Ad Hoc Committee Agenda Item #:	III.A.—Action Item
Date:	June 3, 2019
To:	Magnolia Educational & Research Foundation dba Magnolia Public Schools (“ <b>MPS</b> ”) Ad Hoc Committee (the “ <b>Committee</b> ”)
From:	Alfredo Rubalcava, CEO & Superintendent
Staff Lead:	Patrick Ontiveros, General Counsel & Director of Facilities
RE:	MSA-1 Change Order Requests 6 and 7

Staff recommends and moves that the Ad Hoc Committee approve change orders 6 and 7 presented by Oltmans Construction Co. (“**Oltmans**”) for the new construction project for the benefit of MSA-1 at 18220 Sherman Way (the “**Project**”).

Change order no. 7 consists of CORs/PCIs 28, 29, 31, 32, ~~33~~, and 34 **and 35 and the total cost is \$33,864.94**. Each COR/PCI is explained below. Change order no. 7 with all associated CORs/PCIs is attached as Exhibit B.

**1 BUILDING SECTION**  
S4.0  
SCALE: 1/4"=1'-0"  
NOTES:  
1. FOR INFORMATION NOT SHOWN SEE ARCH'L  
PLANS SECTION 1/AS.1  
2. ELEVATION TO BE VERIFIED W/ARCH'L PLANS  
3. FOR JOISTS/BEAMS/DECK DIRECTION  
SEE PLANS

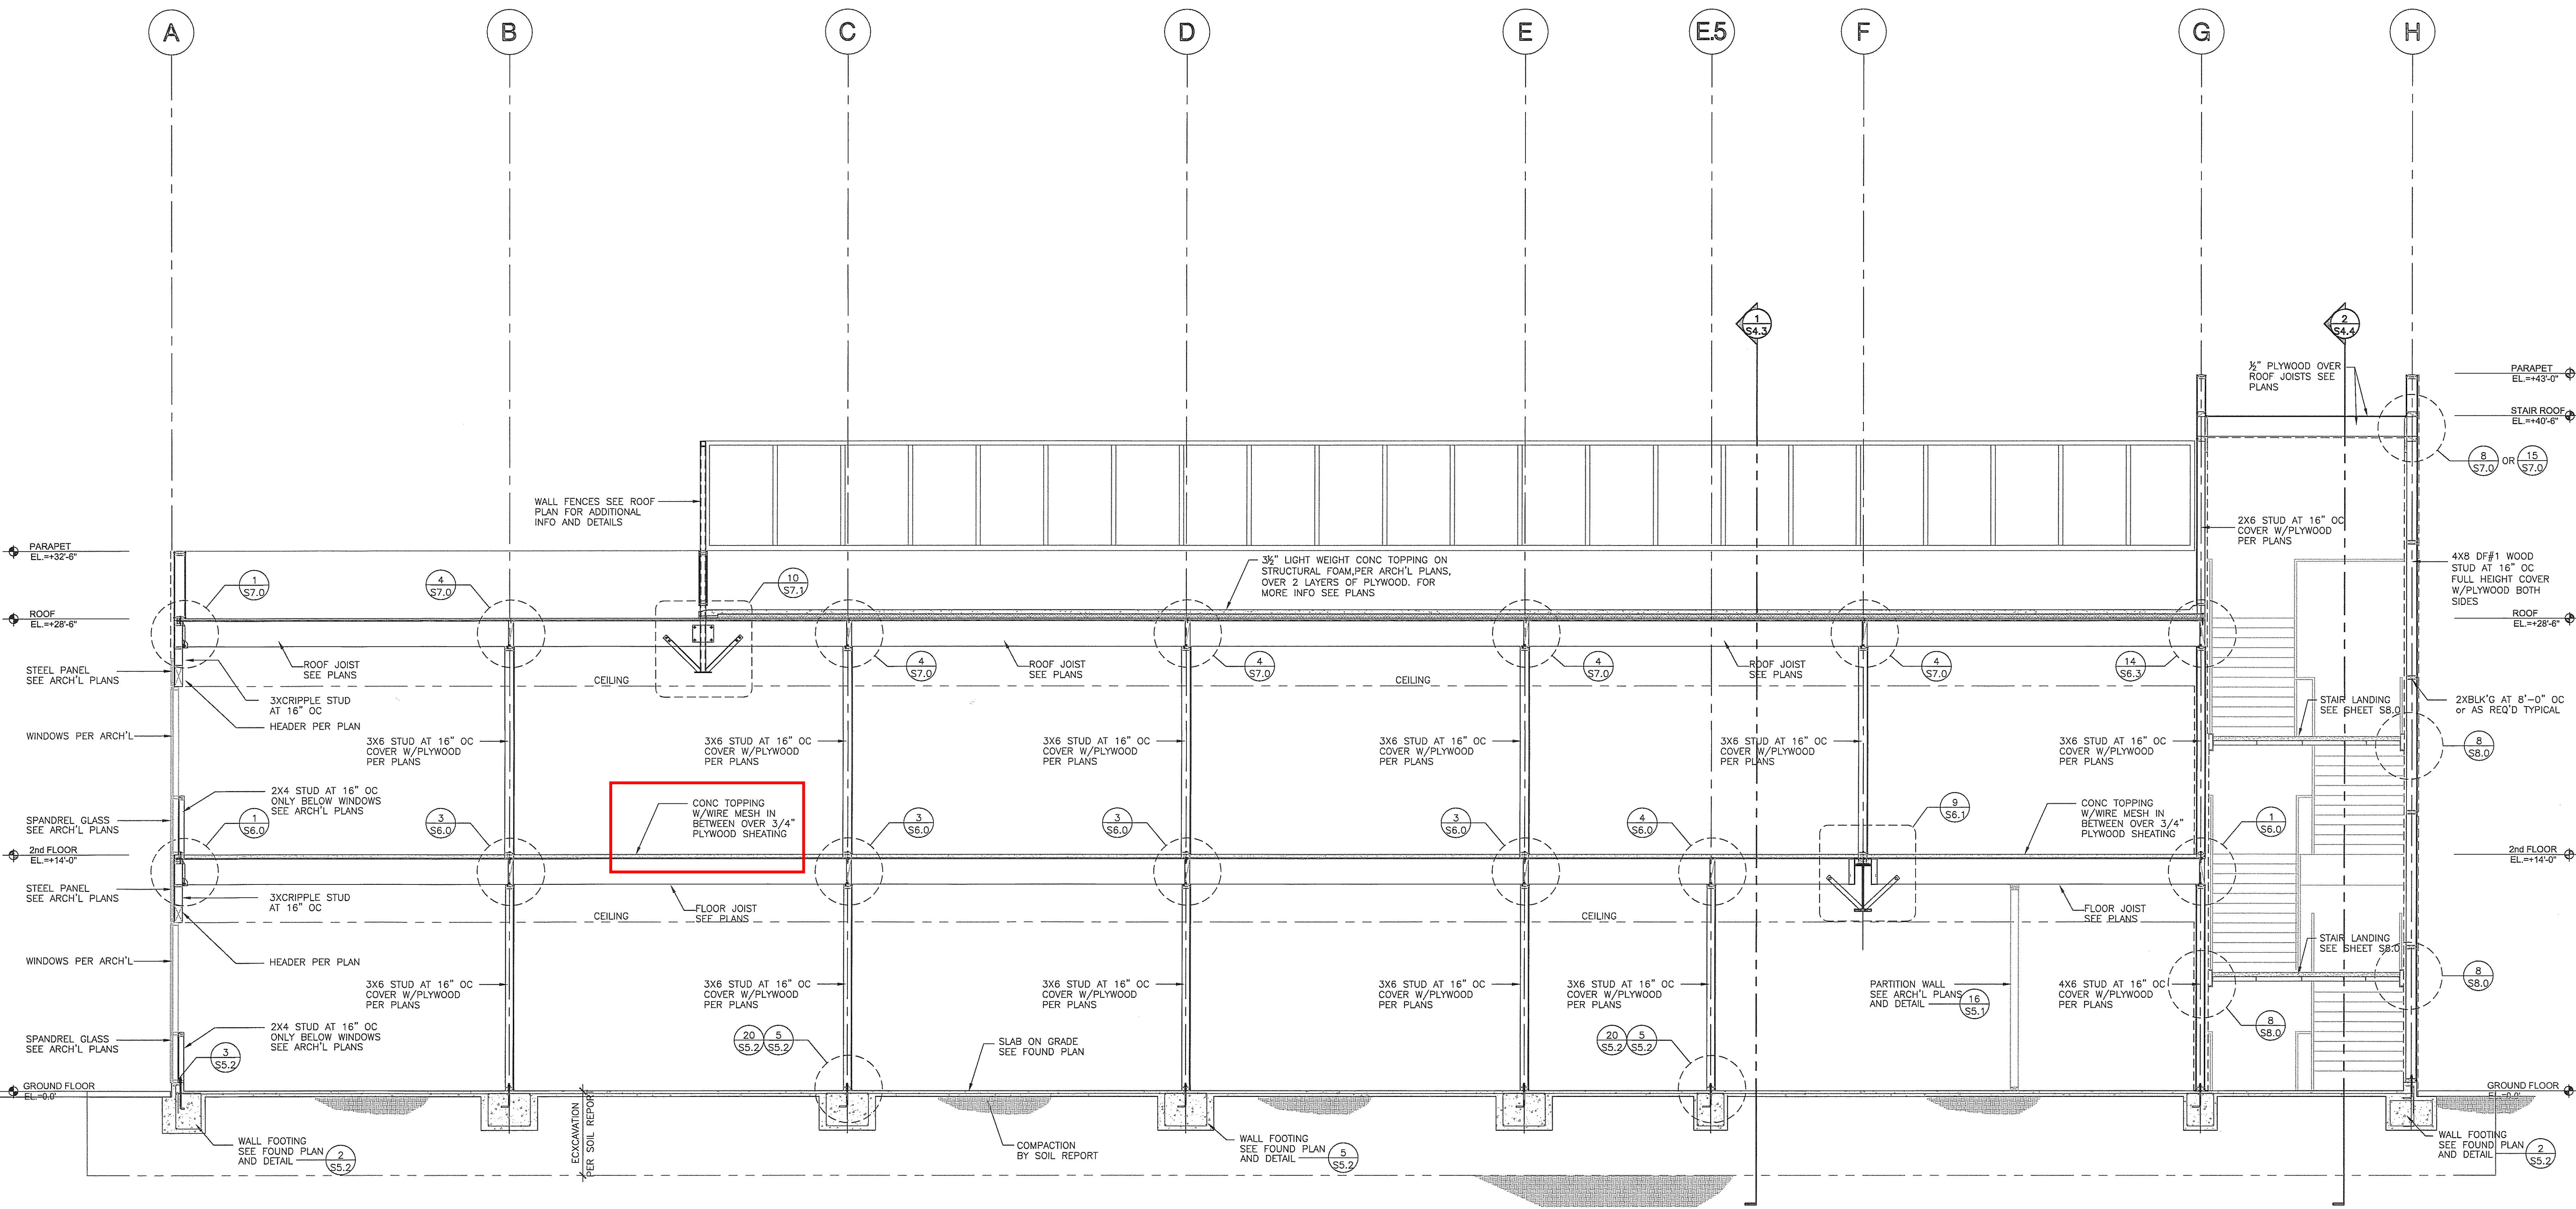
Refer to: S4.0

1. The concrete topping on 2nd floor over plywood is not a standard decking detail and we would like to ensure we are meeting design intent and general functionality.
  - a. Please confirm the +/-2.5" concrete topping slab (4000psi) over ¾" plywood on the 2nd floor is to receive wire mesh per S4.0.
  - b. Please confirm there is NO relief/soft cuts required for this slab.
  - c. Please advise if there are any pre-loading or shoring requirements for the 2nd floor and rooftop decks.

Response to RFI #062 states concrete topping slab to receive wire mesh per note 1 on S2.0. Per OAC meeting on 9/5/2018, owner has requested fiberglass mesh in lieu of wire mesh. Please provide a specification for fiberglass mesh.

1. The floor joists and plywood are designed to support the light weight concrete topping.
  - a. Please make sure the concrete is LIGHT WEIGHT CONCRETE. The concrete topping slab receives wire mesh per notes 1 on sheet S2.0.
  - b. No relief/soft cuts is required
  - c. No pre-loading or shoring is required. The plywood and roof/floor framing is designed to support the extra concrete weight. Please make sure all the roof/floor framing and diaphragm are constructed per approved structural set first. Then the concrete topping can be constructed.

PARKING CHARGING STATIONS - DETAILS

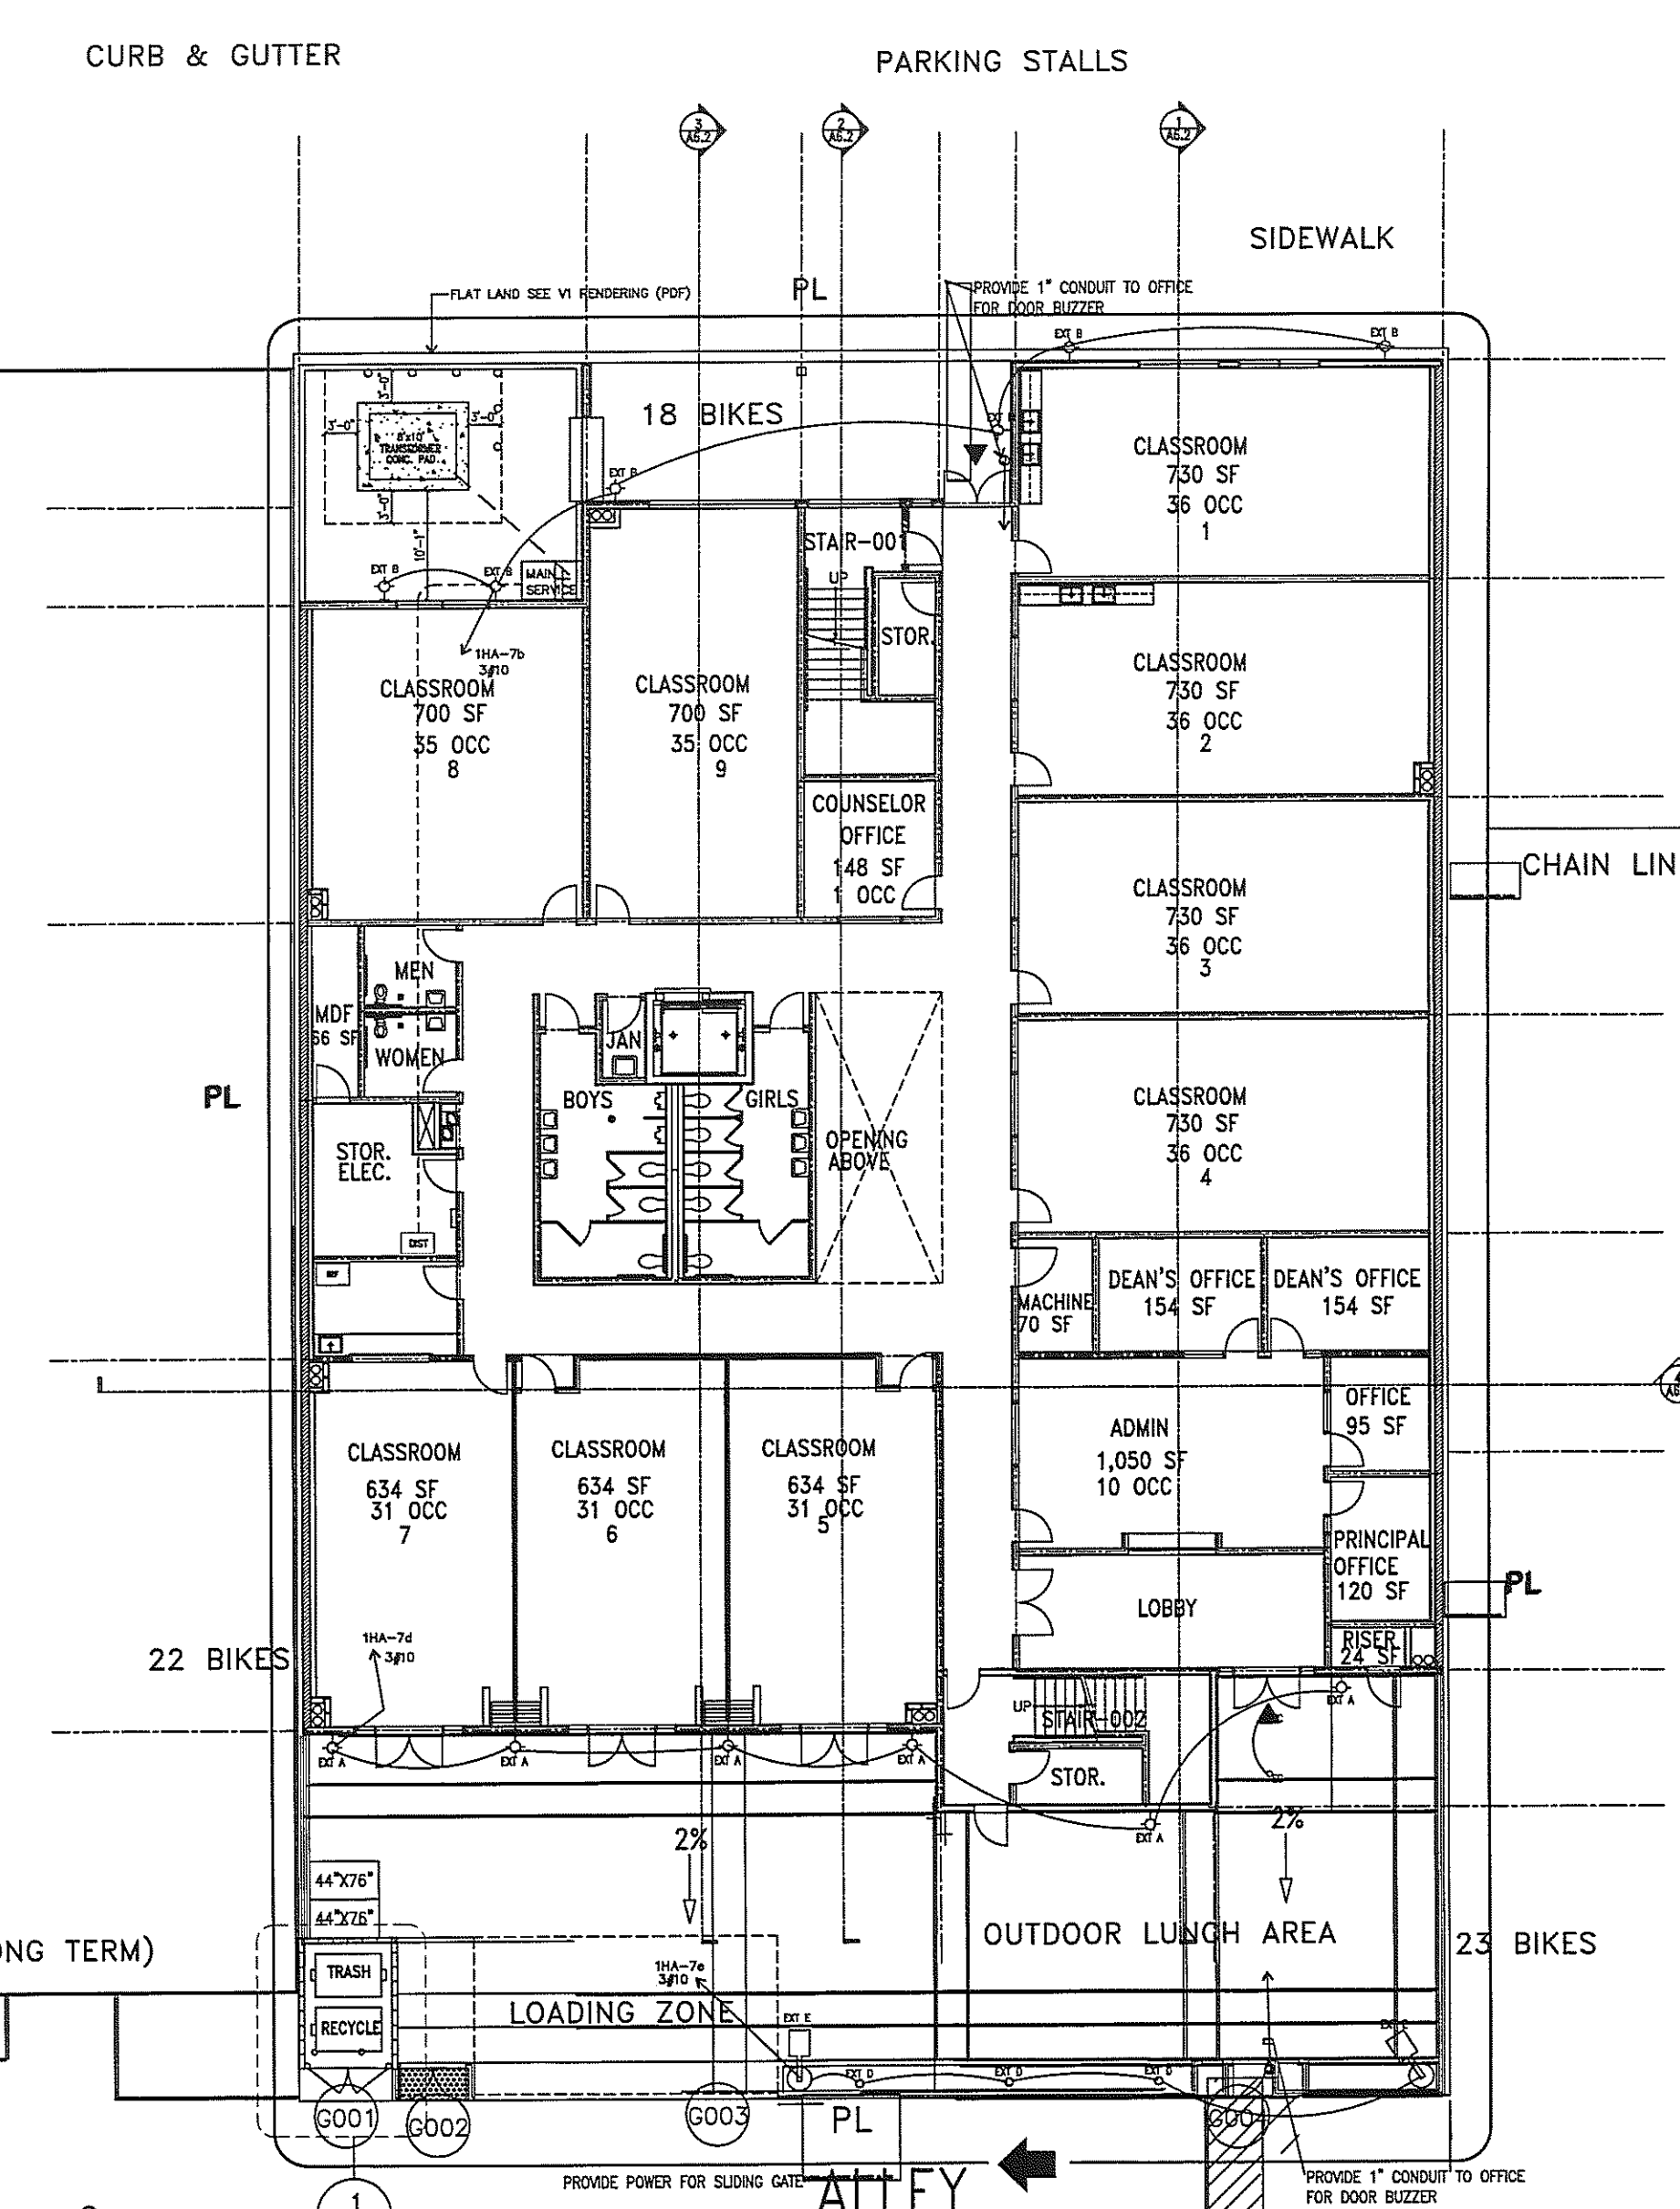
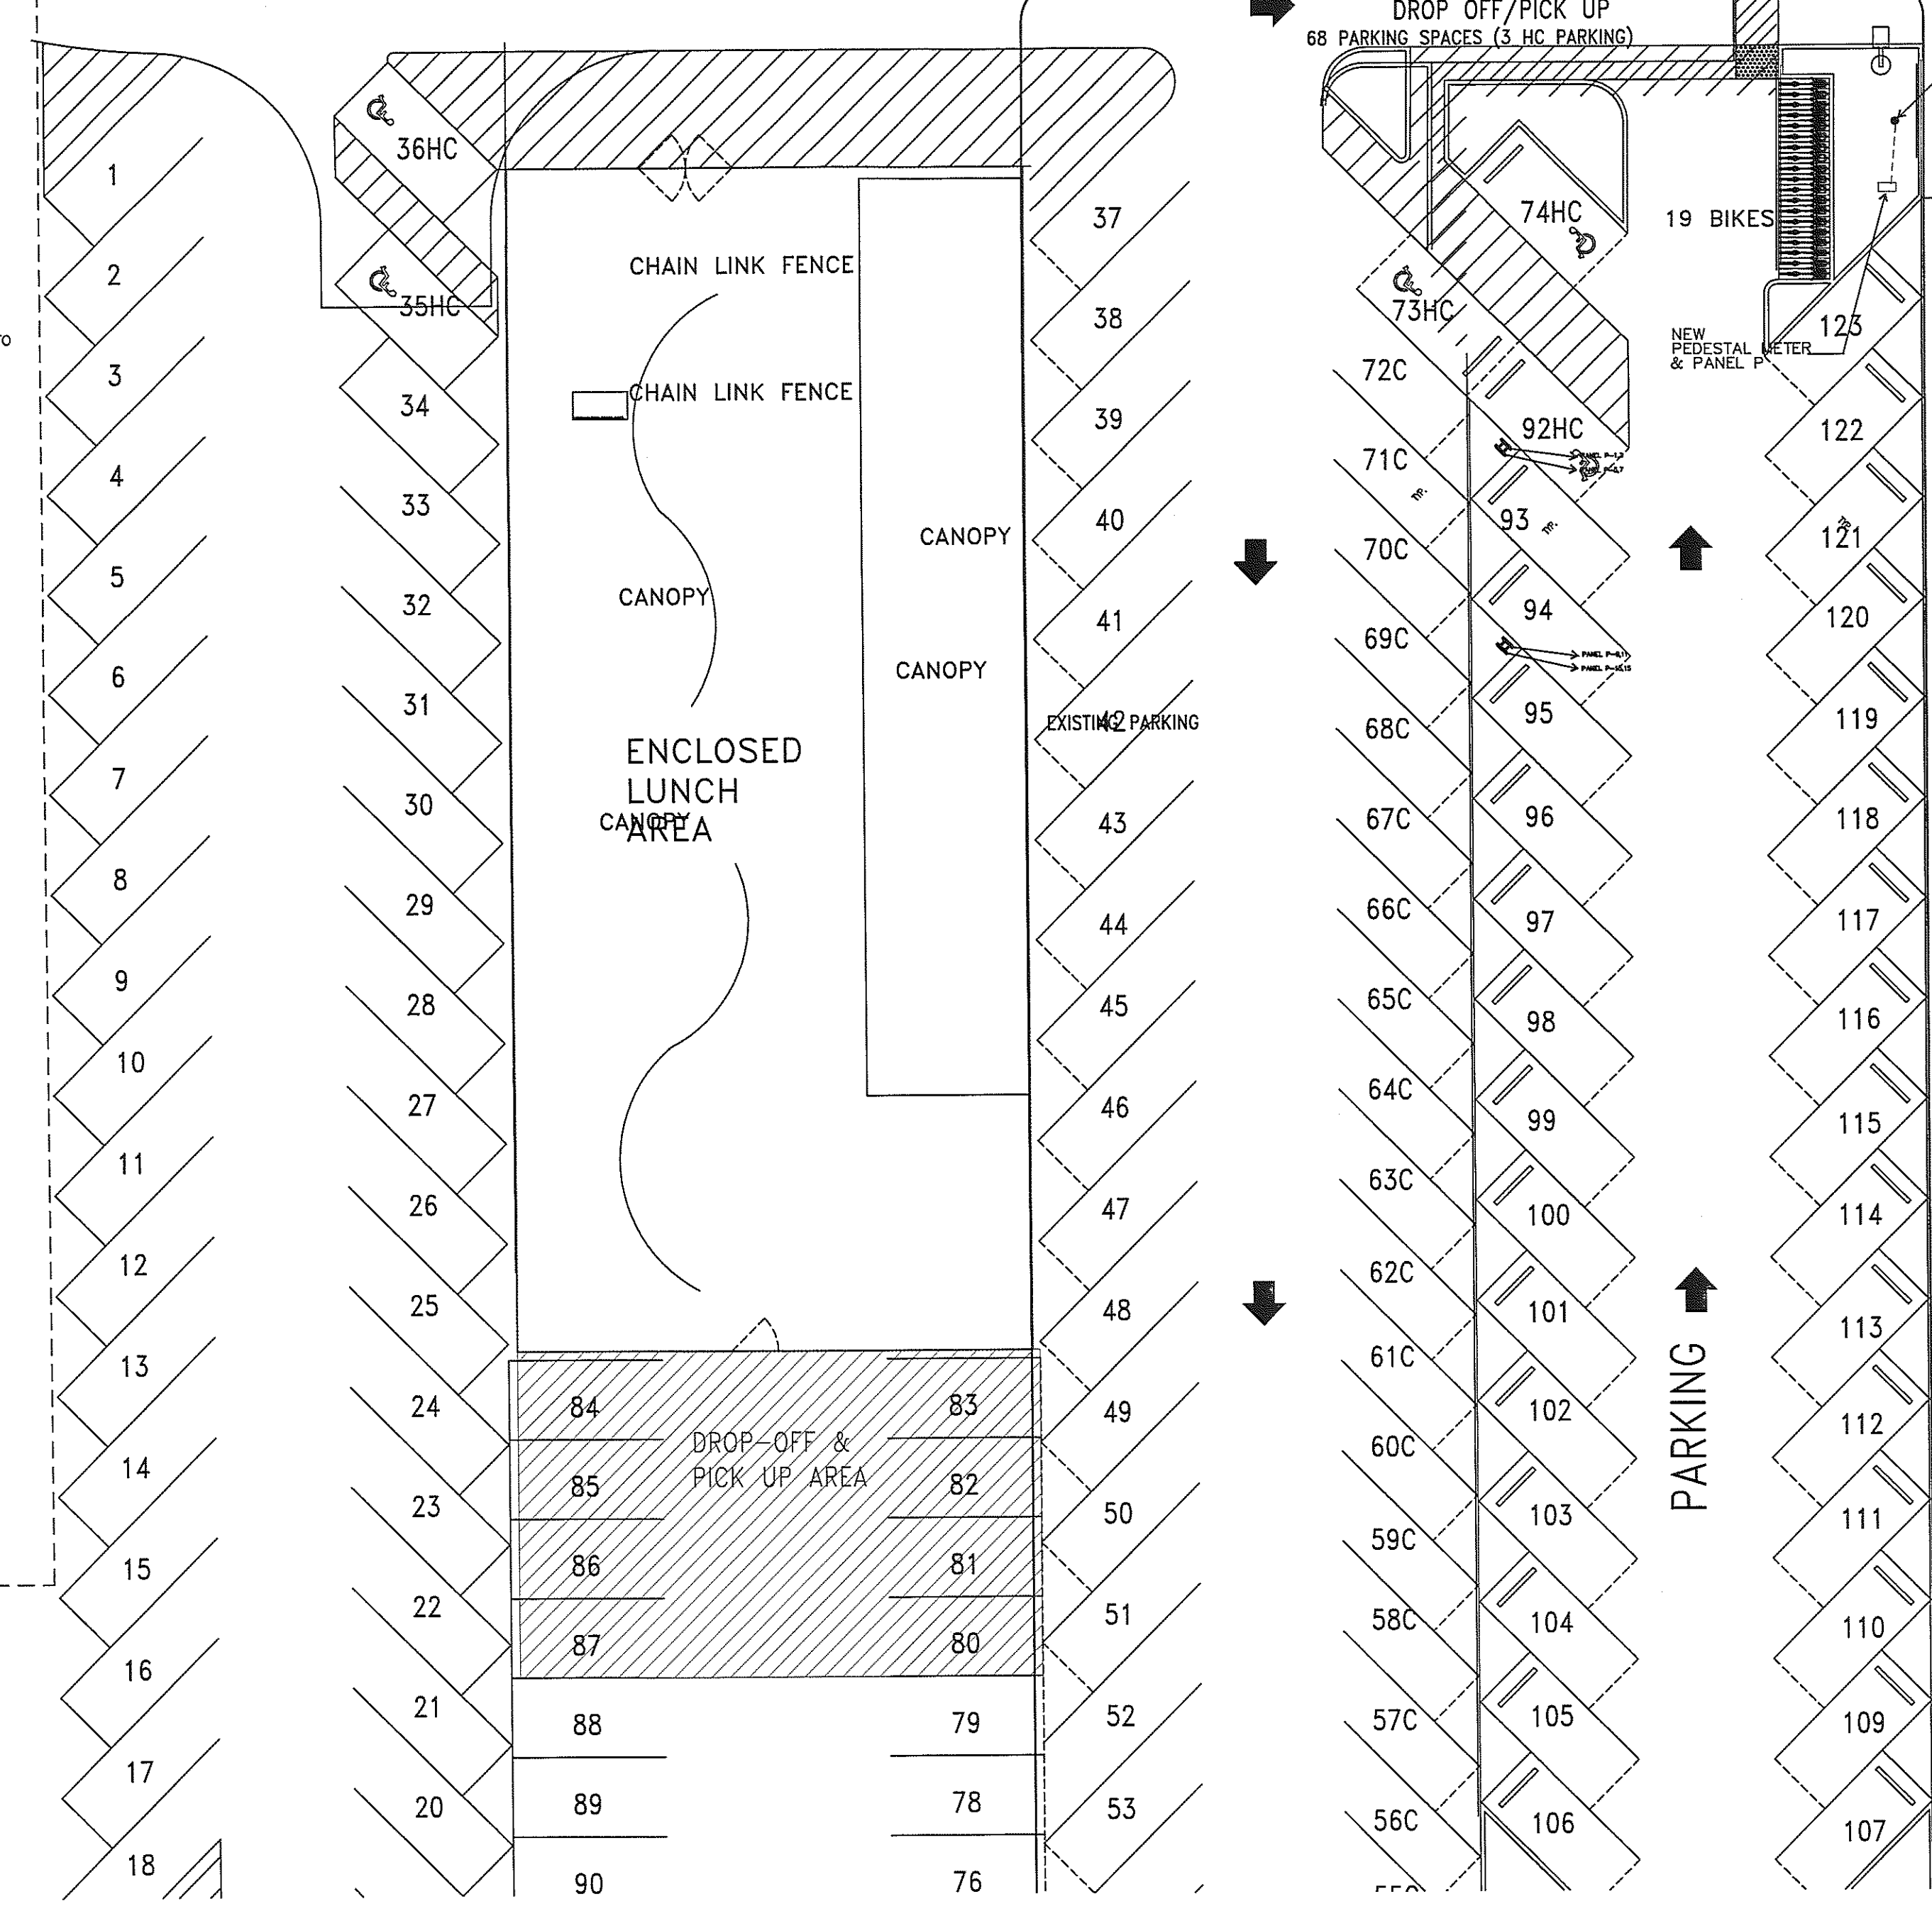
This Potential Change Item (PCI) tracks costs associated with the added labor, materials, and equipment required to install the added LADWP electrical pole not previously included in our scope. Reference E2.1 for site plan.
